SUNDRY NOTICES AND REPORTS ON WELLS
Do not use this form for proposals to drill or to re-enter an abandoned well. Use Form 3160-3 (APD) for such proposals.

San Juan 28-7 Unit 95

Burlington Resources Oil & Gas Company LP requests permission to plug back the Mesaverde and produce the PC only. Please see the attached procedure and well bore schematic. A closed loop system will be utilized for this project.

- **Conditions of Approval:
Plugback Operations**

Schematic - Proposed SAN JUAN 28-7 UNIT #95

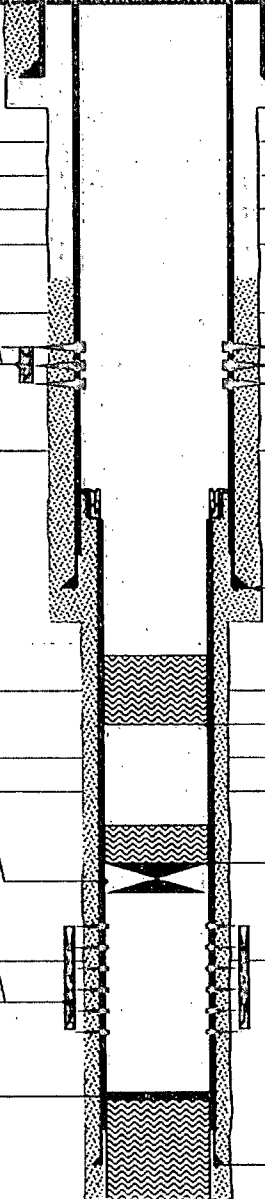
In order to properly plugback this well bore to the Pictured Cliffs Formation, the following amendments are made to your plugback plan:

Note: This well is below the established Charca Line and as such, a Chacra Formation plug is required. In addition, the adjusted formation tops were based on BLM Geologist log interpretations. If CBL results indicate a TOC below the 5 ½" liner top, please contact this office accordingly.

- 1) Plug #1 is acceptable as proposed.
- 2) Modify plug #2 for the Mesaverde Formation top (Cliff House top @ 4886') from 4936' to 4836'. Spot 17 sacks of cement as proposed.
- 3) Spot Chacra Formation plug (Chacra top @ 4261') inside 5 ½" casing from 4311' to 4211' with 17 sacks of cement as proposed.
